PRODUCT / PROCESS CHANGE NOTIFICATION
PCN-000751
Date: 12-29-2021

Part Number(s) Affected: -TS14002-C012DFNR; -TS14002-C015DFNR; -TS14002-C018DFNR; -TS14002-C020DFNR; -TS14002-C023DFNR; -TS14002-C025DFNR; -TS14002-C033DFNR;	Customer Part Number(s) Affected: <input checked="" type="checkbox"/> N/A
---	--

Add Carsem Ipoh to support production Assembly & Final Test

PCN No. 000751
Qualification of Carsem Ipoh for TS14002-C0XXDFNR products

Assembly Process Flow Comparison for CarsemSZ (Old) vs. CarsemIPH (New)

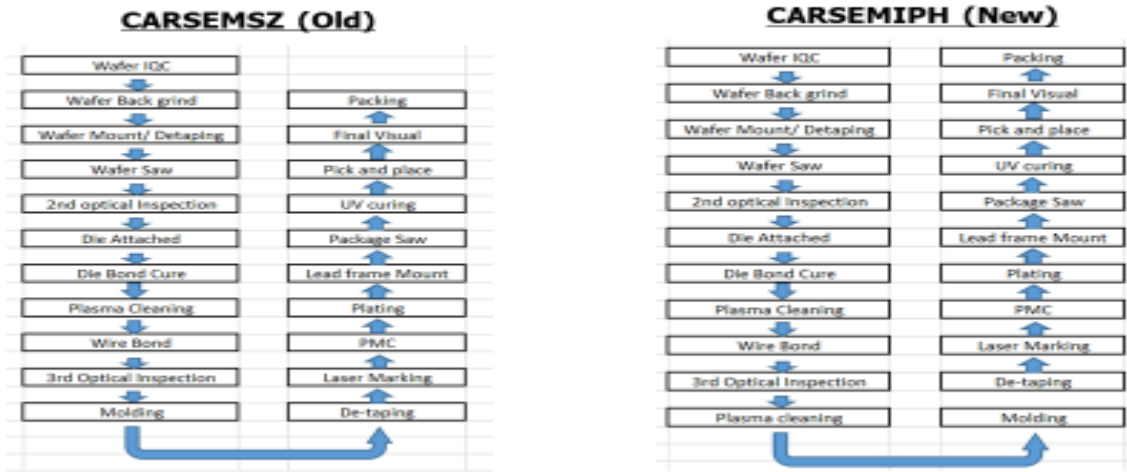
- No major Change in manufacturing Flow for both Assembly site CarsemSZ versus CarsemIPH except additional process step for plasma cleaning before mold for CarsemIPH.

Lead frame outline Comparison CARSEMSZ (OLD) Vs CARSEMIPH(NEW) for TS14002-C0XXDFNR

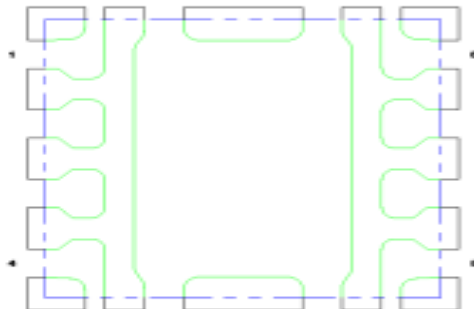
Die Pad :1.1 x 1.7mm
Exposed Pad : 0.9 x 1.7mm

No Difference on lead frame outline for CARSEMSZ and CARSEMIPH as both are using the same lead frame.

**Bonding Layout (CarsemSZ vs
CarsemIPH) for TS14002-C0XXDFNR**

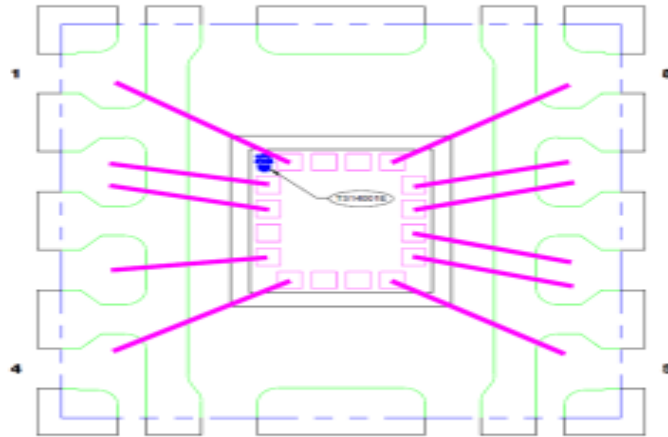
No Change in Bonding Layout.
